CONDITION OF CONCERN

OUTLINE OF REPAIR

Fuel Tank (Mazdaspeed6)

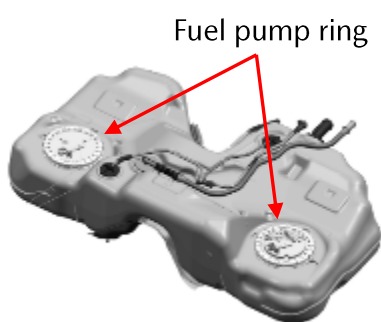
On Mazdaspeed6 and RX-8 vehicles, improper installation of the fuel pump mounting rings may lead to cracking of the rings, causing fuel leakage. In addition, on RX-8 vehicles, due to insufficient heat resistance at the top side of the fuel tank, the fuel pump mounting rings may deteriorate due to heat exposure from the engine and exhaust pipe which may also lead to cracking of the rings, causing fuel leakage. Fuel leakage may result in increased risk of fire in the presence of an ignition source near the vehicle.

New fuel pump mounting rings will be installed on Mazdaspeed6 and RX-8 vehicles. In addition, thermal insulation pad will be added to the fuel tank on RX-8 vehicles.
